1690 WEST 8TH AVENUE (COMPLETE APPLICATION)
DE408976 - ZONE C-3A

DEVELOPMENT PERMIT STAFF COMMITTEE MEMBERS

DEVELOPMENT PERMIT STAFF COMMITTEE RECOMMENDATION: APPROVE

Figure 2. Massing and Shadow Analysis

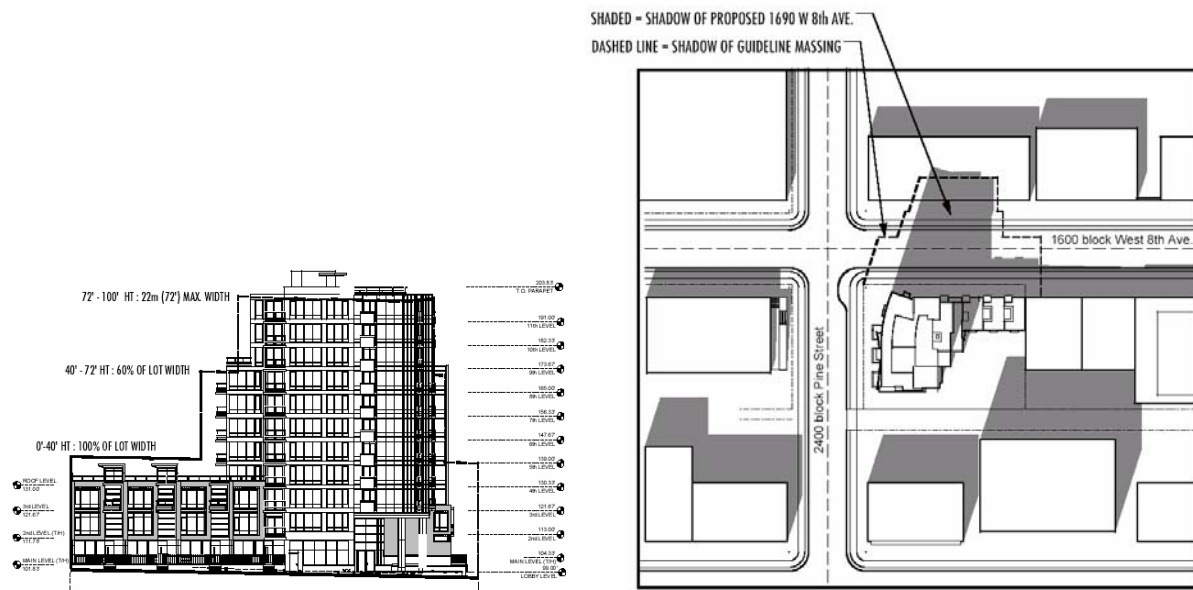
Height, Massing and Density: As noted in the Technical Analysis Chart for the Guidelines on pages 4 and 5, the proposal requests several variations to the guideline recommended height and massing. As shown in the diagrams below, these are very minor variations and are balanced by a massing that is less than the guidelines suggested. The variations in massing also do not create additional view intrusion. On that basis, staff support the requested variations. The east elevation requires some design development to simplify the massing and rhythm as suggested by the Urban Design Panel. (Condition 1.2)

1.2 design development to the east side of the tower to simplify the massing and rhythm;
and
